DRC-2021-003475

CD-2021-030

Re: Radioactive Material License UT 2300478 -
Groundwater Quality Discharge Permit UGW450005; **Revised Amendment and
Modification Request to Reduce Capacity and Disposal Footprint**

ENERGYSOLUTIONS
 CLIVE FACILITY
 11e.(2) DISPOSAL CELL
 PROJECT TITLE SHEET
 CLIVE, UTAH

ENERGYSOLUTIONS
 CLIVE FACILITY
 11e (2) DISPOSAL CELL
 REVISED CELL GENERAL PLAN
 CLIVE, UTAH

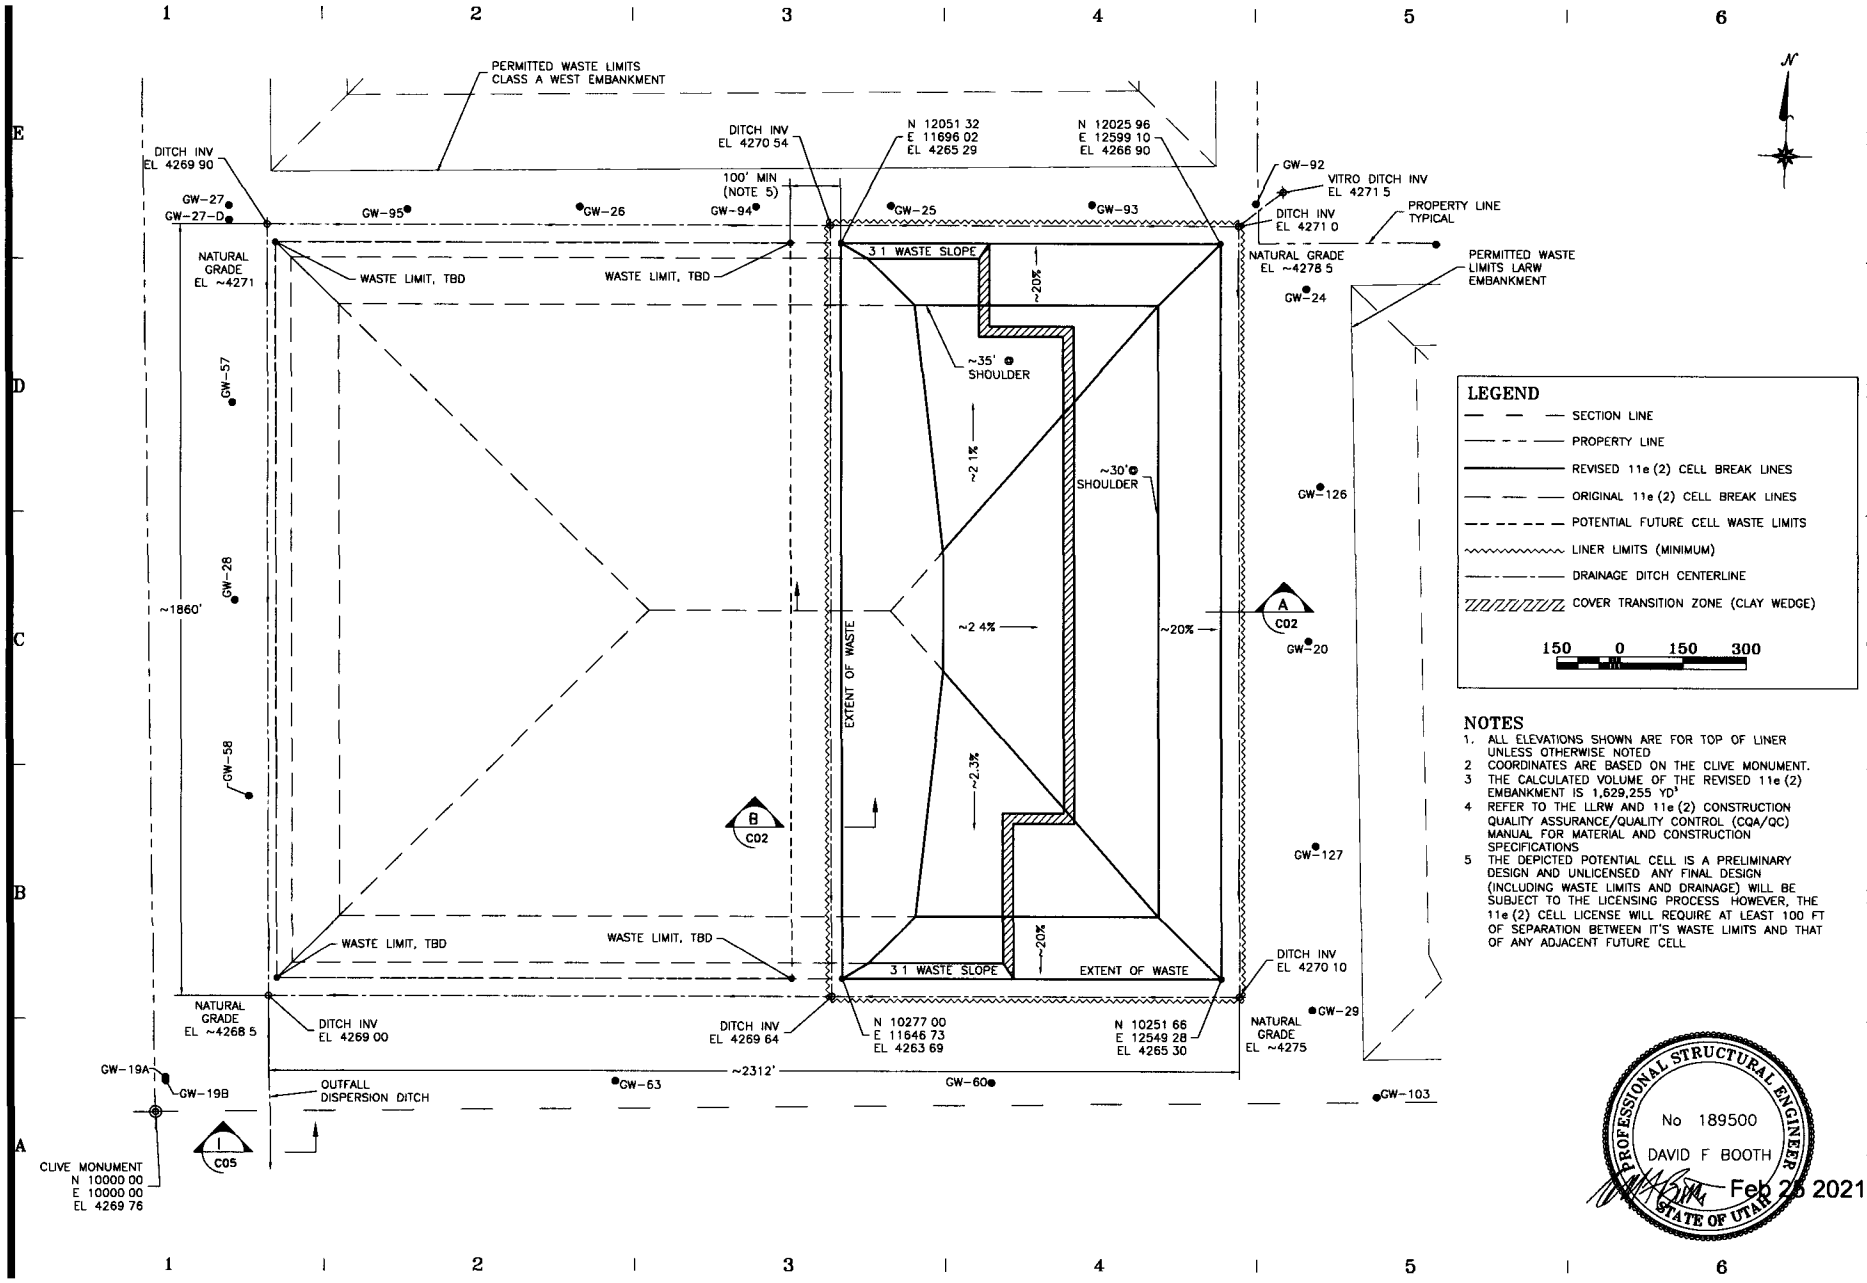
2/25/21 1078 FOR LICENSE AMENDMENT - REVISED AREA BETWEEN CELLS
 1/10/19/2005 FOR LICENSE AMENDMENT
 DATE BY DESCRIPTION OF CHANGE

ENERGYSOLUTIONS
 CLIVE FACILITY
 11e (2) DISPOSAL CELL
 CELL CROSS SECTIONS, 2 OF 2
 CLIVE, UTAH

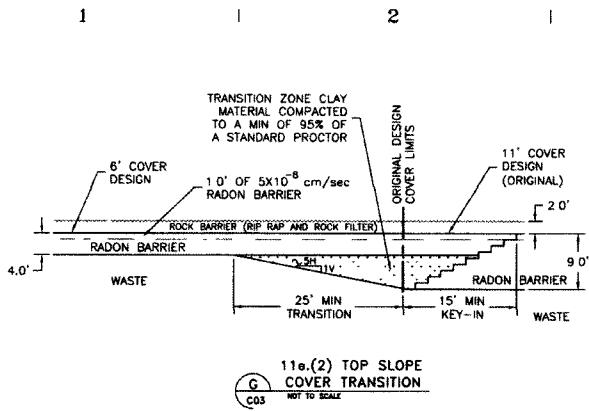
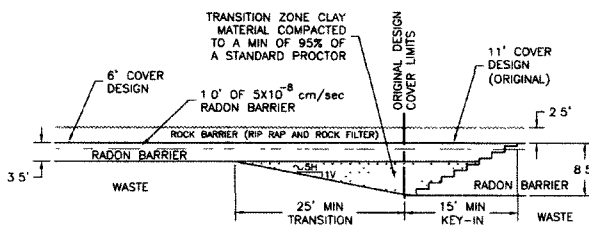
DATE	DESCRIPTION OF CHANGE
10/25/20	FOR LICENSE AMENDMENT
11/25/21	FOR LICENSE AMENDMENT - REVISED CROSS SECTION D

CLIVE FACILITY
11e(2) DISPOSAL CELL
DISPOSAL CELL BUFFER ZONE
CLIVE, UTAH

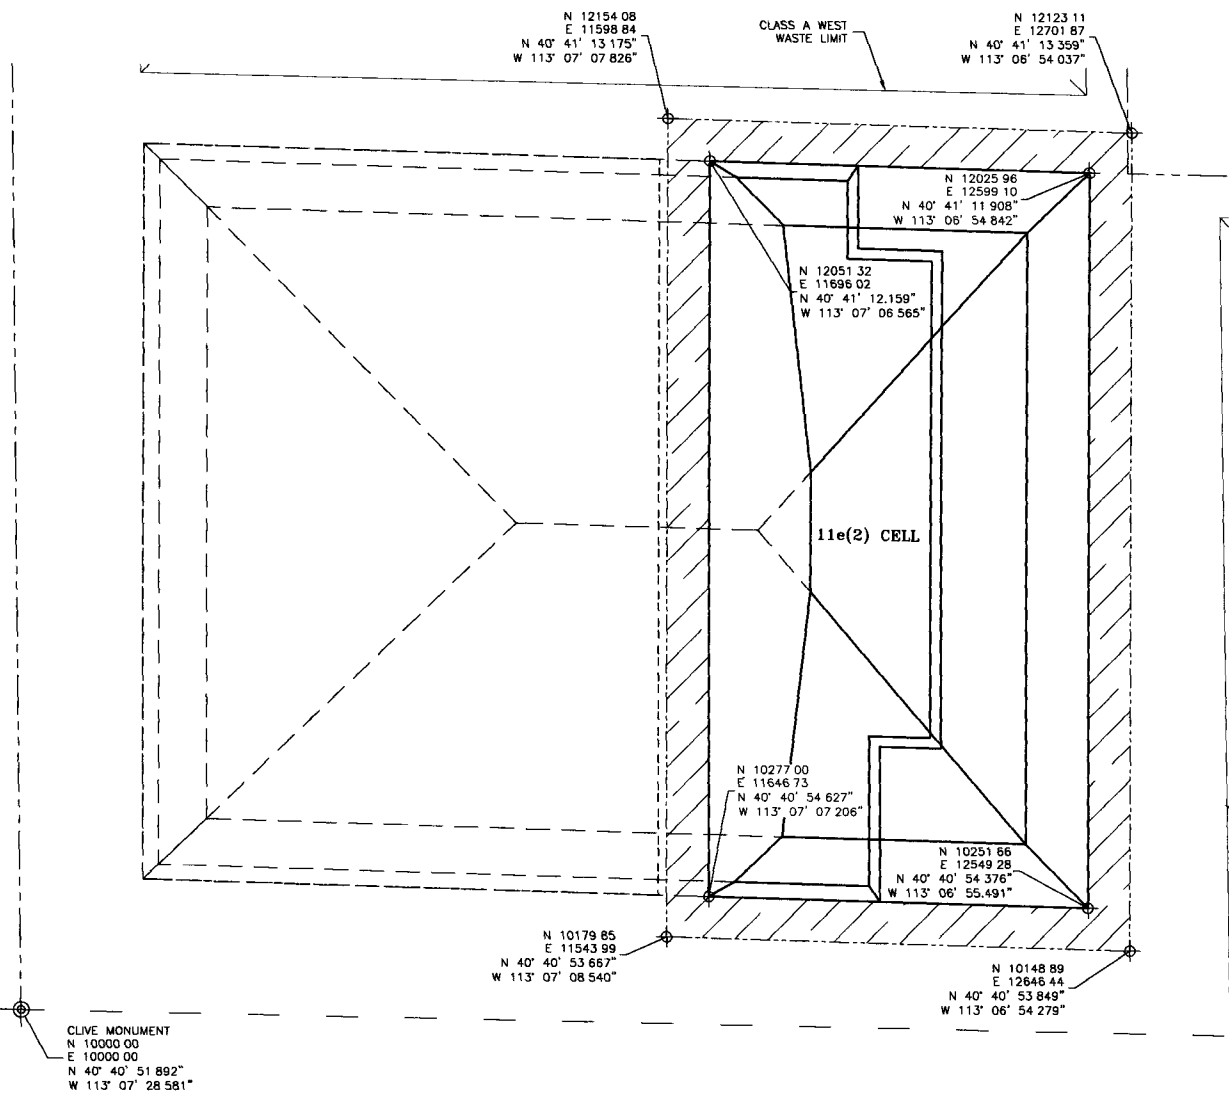
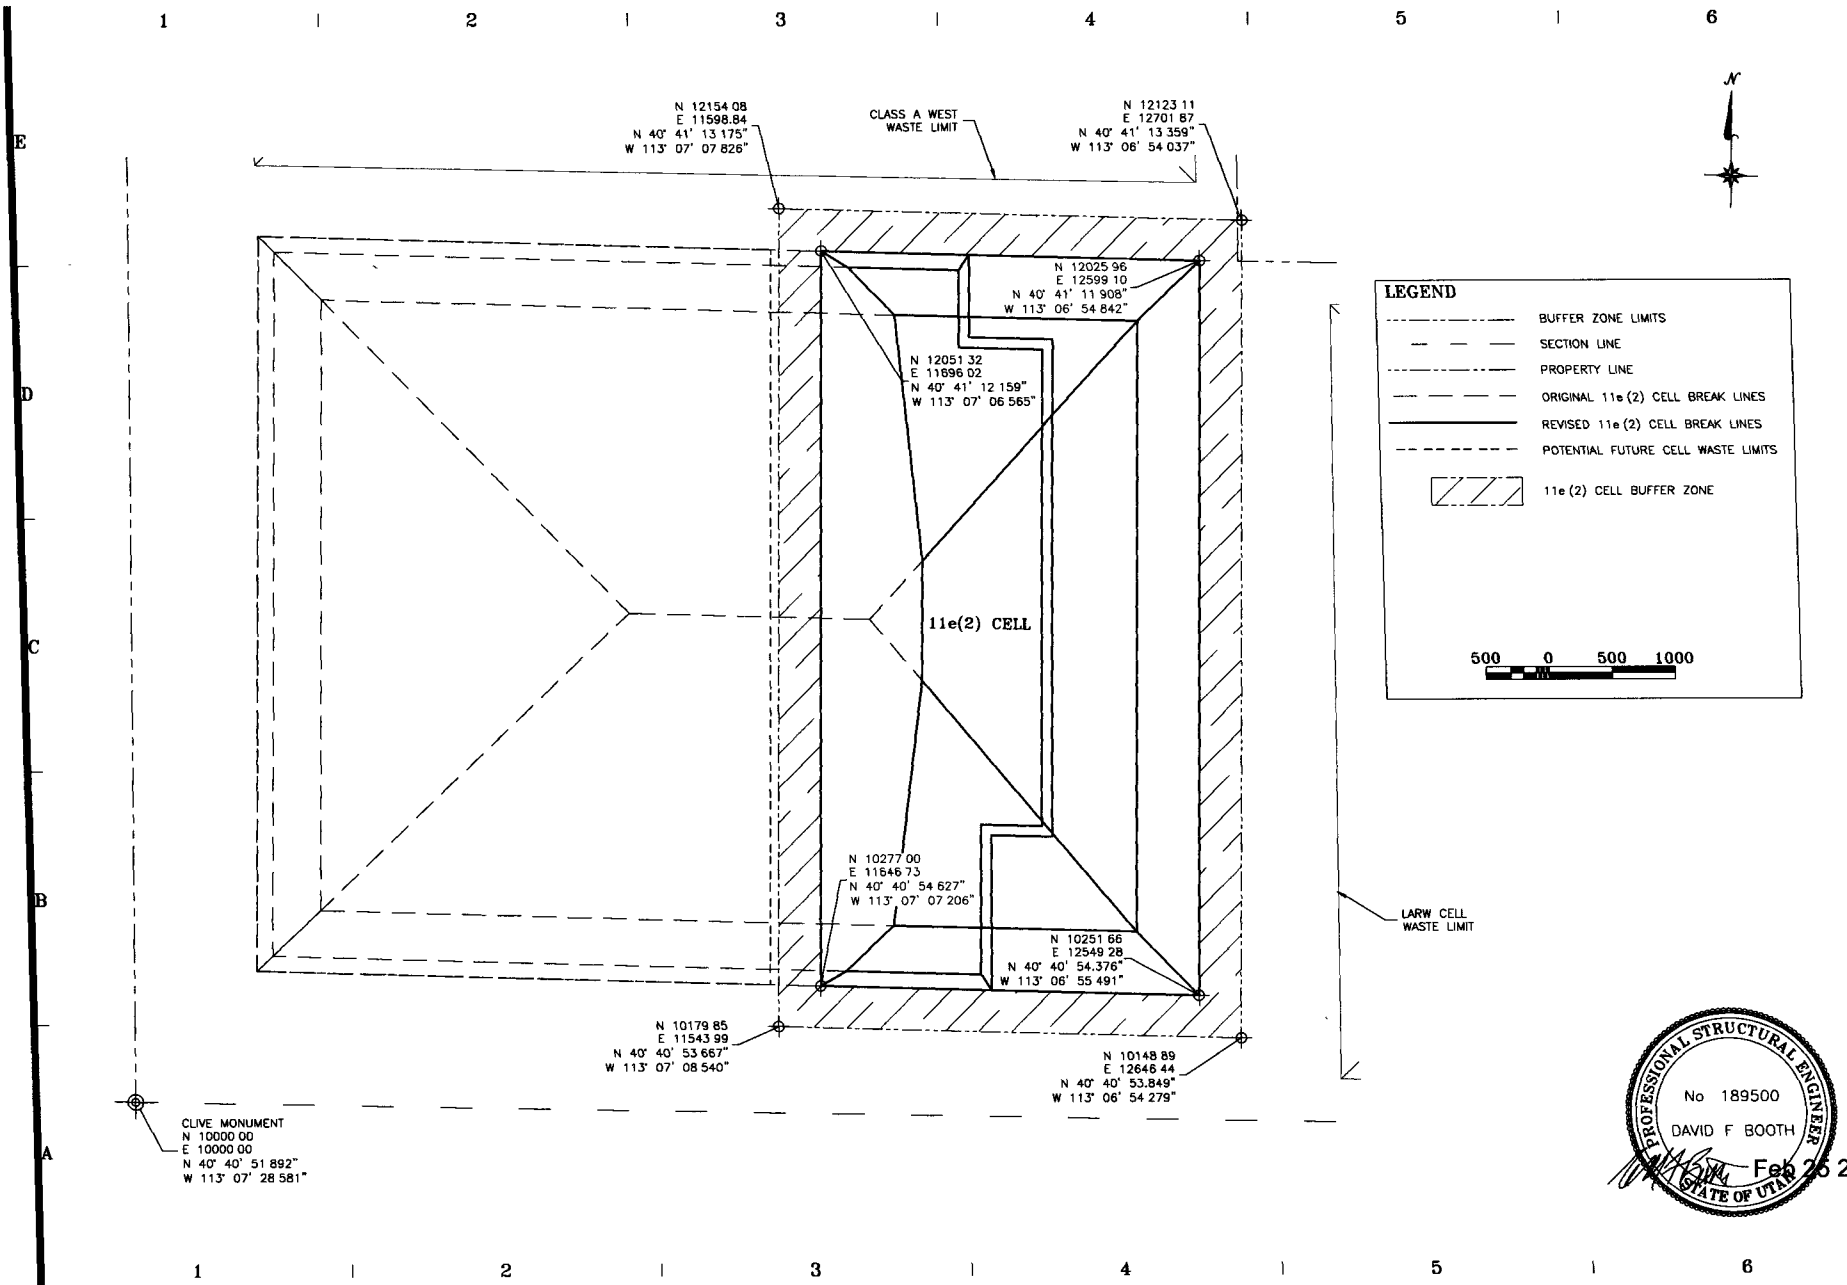
NO.	DATE	DESCRIPTION OF CHANGE
1	2/25/21	FOR LICENSE AMENDMENT-REVISED BUFFER ZONE WEST LIMITS
2	10/20/20	FOR LICENSE AMENDMENT

DATE BY DESCRIPTION OF CHANGE
 2/25/21 DFB FOR LICENSE AMENDMENT-REVISED BUFFER ZONE WEST LIMITS
 10/05/20 DFB FOR LICENSE AMENDMENT
